Letter: **ST-008-2020**

Subject: **Blower motor noise during shut-down – Regal Beloit Ensite® Blower Motors.**

Product: TM8X, TMLX, TM9X, TM9E, TM9Y, RGF19\*E, RGF29\*E, RGF1L\*E, RGF2L\*E, MM9E

Summary: **This letter provides explanation and resolution for complaints of blower motor noise occurring during motor shut-down.**

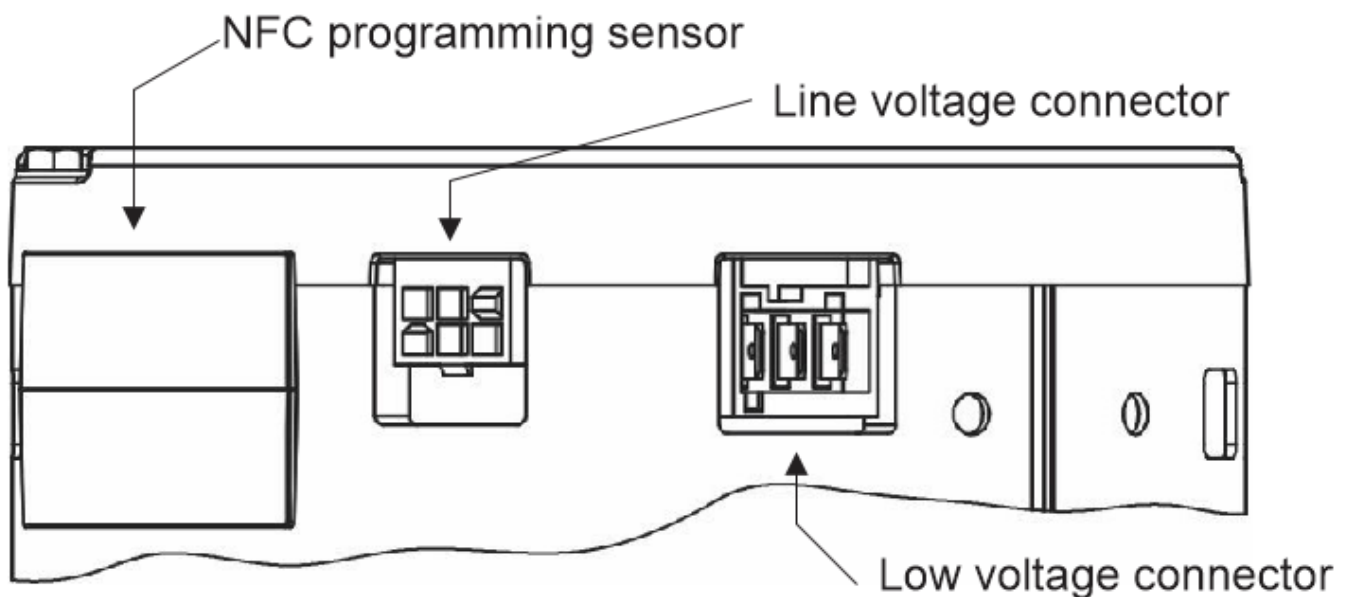
Starting in early 2019, some furnace blower motors have been changed from Regal Beloit EnduraPro® motor to the Regal Beloit Ensite® motor. The Ensite® motor has several unique features to differentiate it from the EnduraPro® motor. The motor is lighter in weight, has better performance, can be programmed using NFC (near field communications) and the electrical connections are on smaller simple connectors in lieu of individual speed tap connectors. The Ensite motor can be easily identified by its unique electrical connections. An image of the Ensite motor connections is shown below.
